**DEVELOPMENT APPLICATION 675/2017 – MIXED USE DEVELOPMENT –
 482 THE ESPLANADE, WARNERS BAY.**

ATTACHMENT A

DETAILED RESPONSE TO CONDITIONS

THE ESPLANADE - OVERLOOKING STUDY

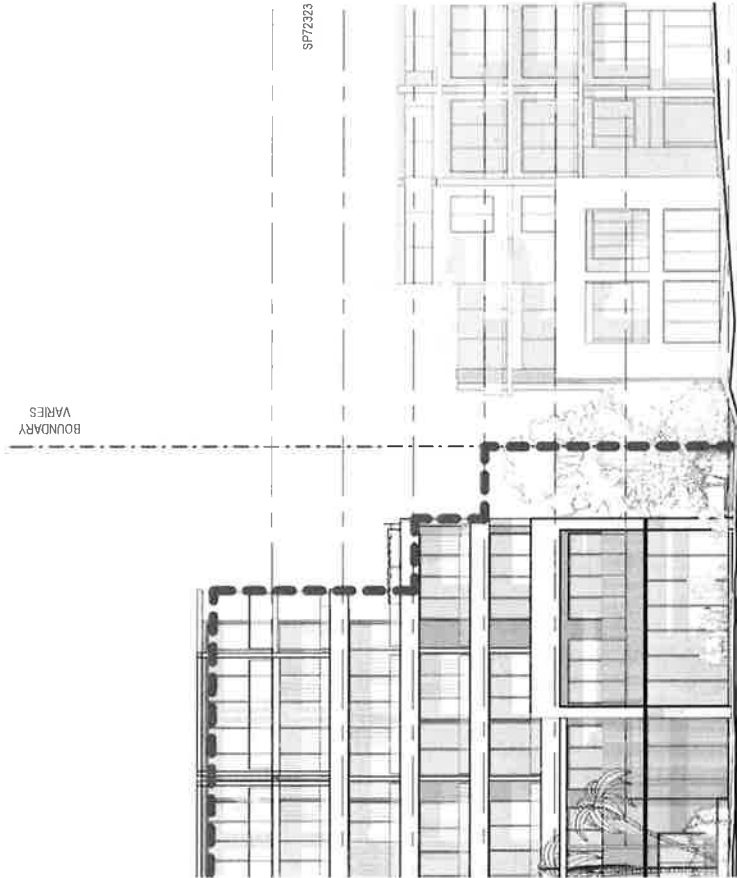
The fourth level of residential units has a perimeter planter with handrail barrier setback from the building edge. This prohibits overlooking to the neighbouring building below, allowing outlook over rooftops only.

Revised Basement Plan

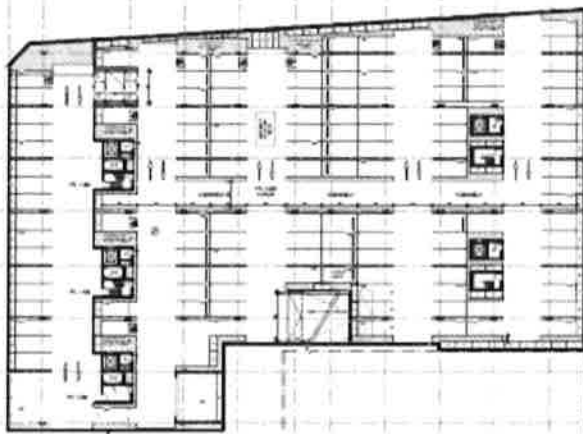
The size of the lower basement has been increased toward The Esplanade to accommodate additional car parking. This makes provision for 36 shared parking spaces. (NB: the full 37 shared spaces are no longer required because of the reduction in commercial floor space).
